ECHNICAL INFORMATION

Subject Change of Flat Washer 45 and Lock Sleeve Guide

For Models **HR4001C**, HR4010C, HR4011C

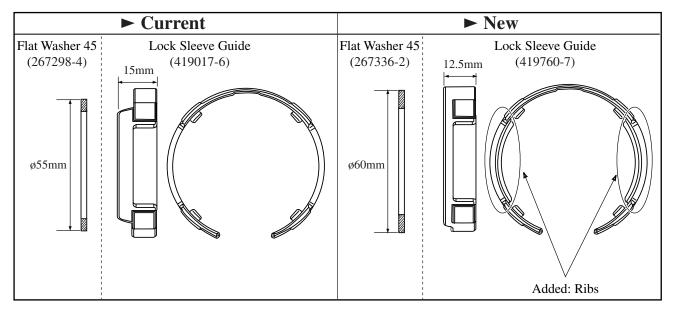
Description Outer diameter of Flat washer 45 and Shape of Lock sleeve guide have been changed as illustrated below.

Item No.	Current part	Q'ty	I/C	New part	Q'ty	Note
010	Flat Washer 45 267298-4	1	No	Flat Washer 45 267336-2	1	Interchangeable as a set
009	Lock Sleeve Guide 419017-6	1	No	Lock Sleeve Guide 419760-7	1

HR4001C: From serial No. 38183E (July, 2006) HR4010C, HR4011C: From July 2006 production
